Source: Leece-Neville Heavy Duty Systems Division - Arcade, NY USA
 Date: JULY 7, 2017
 Bulletin No: TSB-1135
 Models: 8MR3300G (110-465)
 Subject: Replacement procedure

8MR3300G (110-465) is being discontinued. Diagram below will show you how to replace this alternator with a 8MR3301G (110-486).

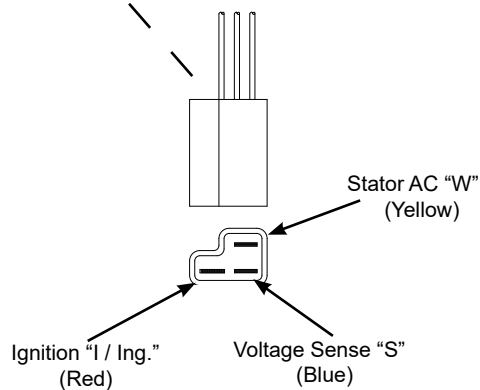
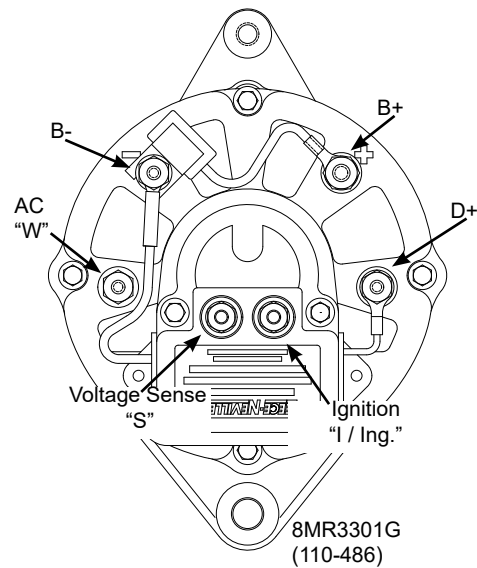
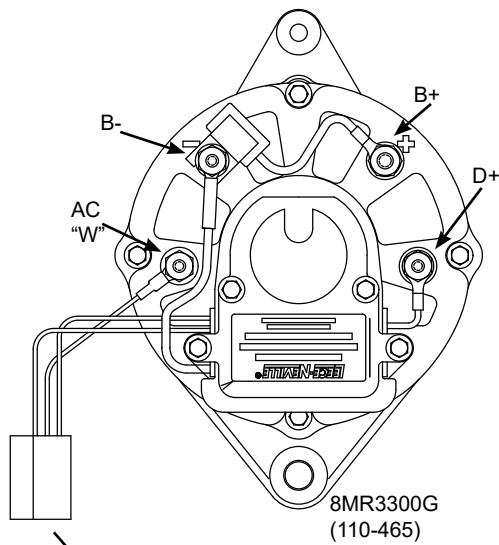
Connects to:	
8MR3300G	→	8MR3301G
Yellow wire (AC / W)	→	AC / W Terminal
Blue wire (S)	→	S Terminal
Red wire (I / Ing.)	→	D+ Terminal
B+ Terminal	→	B+ Terminal
B- Terminal	→	B- Terminal
		I / Ing Terminal: No connection
